Model: See models affected	Jan. 3, 2018
Serial #: N/A	
Product Bulletin # PDC-016

Top Drive Control Power Modification in Driller Cabin

Figure 1: Wiring Before Changes on CB7 and TB34. Current Rig 1202.

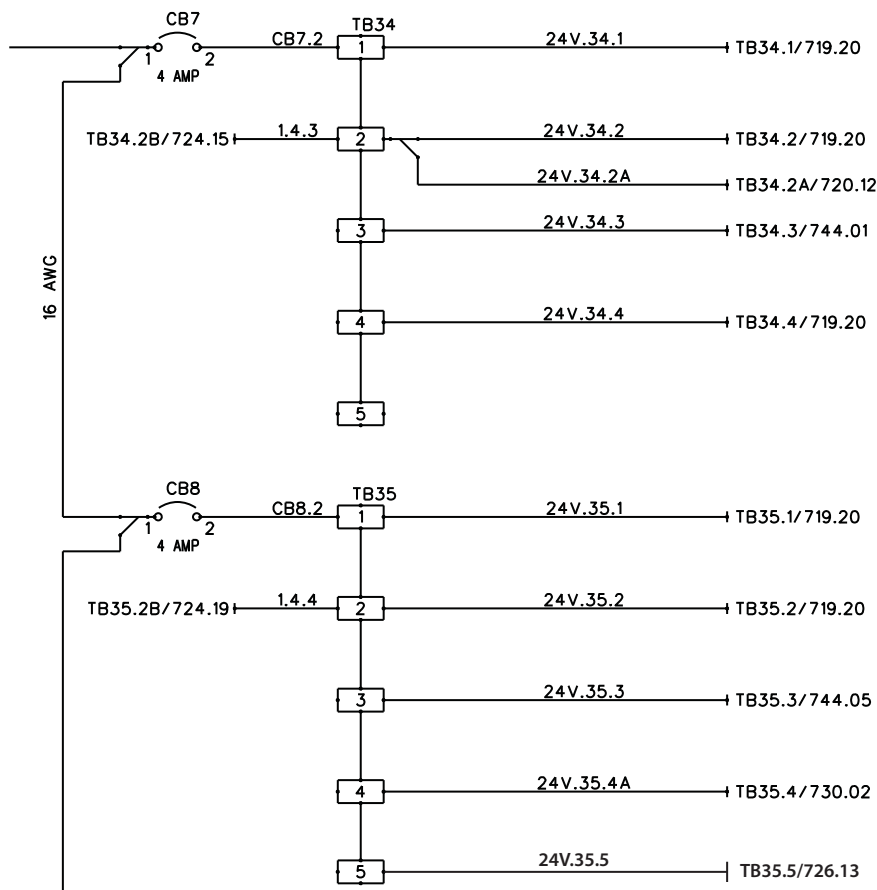
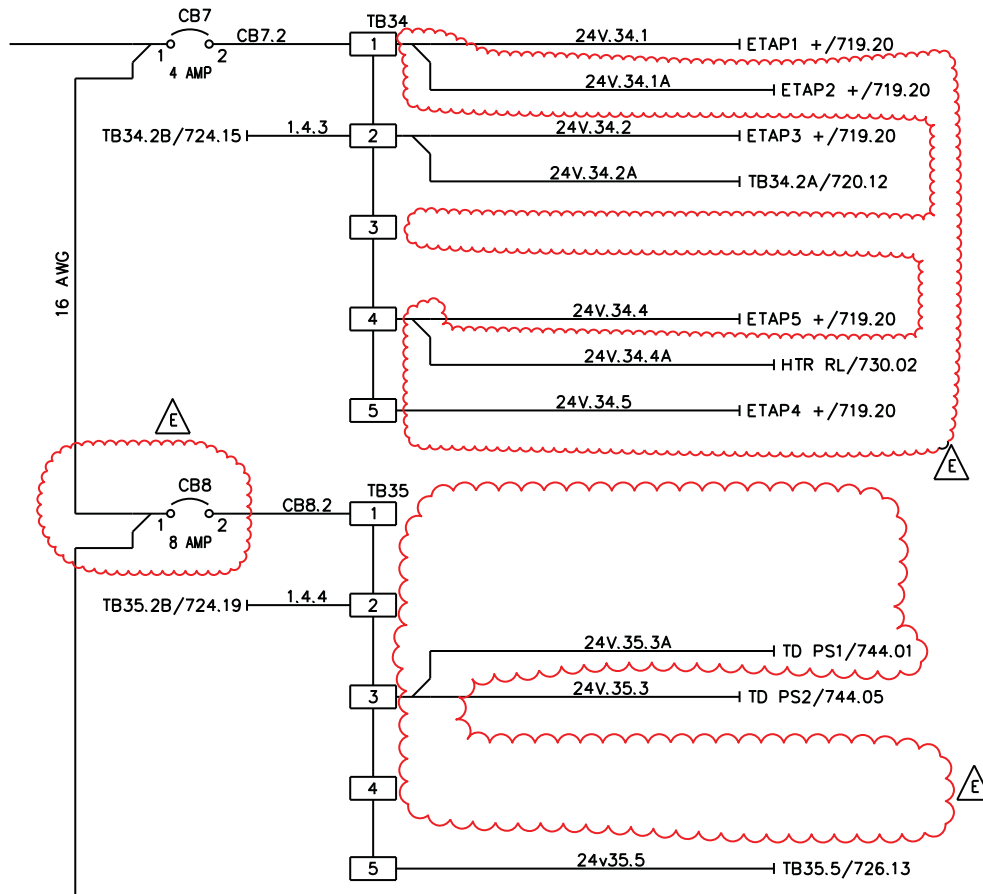
Some PACE-X rigs may lose top drive control power as a result of circuit breaker 7 (CB7) tripping. This condition is caused by overcurrent on the circuit after installing the oil quality sensor.

- Note that the 4 A circuit breaker 8 (CB8) will be replaced by an 8 A breaker.
- All wires not related to top drive control power will be moved from TB35 and placed on TB34 terminal strip.
- All wires that are for top drive control power are moved and dedicated to CB8 and terminal strip TB35.
- See Figure 1 below and Figure 2 on page 3.
- See Table 1 on page 4 and Table 2 on page 5 for details.

1. Replace CB8, 4A circuit breaker with 8A circuit breaker supplied with the kit. See Figure 2.

2. Move wire number 24V.35.1 from TB35:1 to TB34:1. Relabel this wire to 24V.34.1A (ETAP 2 Power).
3. Move wire number 24V.35.2 from TB35:2 to TB34:5. Relabel this wire to 24V.34.5 (ETAP 4 Power).
4. Move wire number 24V.35.4A from TB35:4 to TB34:4. Relabel this wire to 24V.34.4A (HTR relay coil).
5. Move wire number 24V.34.3 from TB34:3 to TB35:3. Relabel this wire to 24V.35.3A (TD 24VDC).
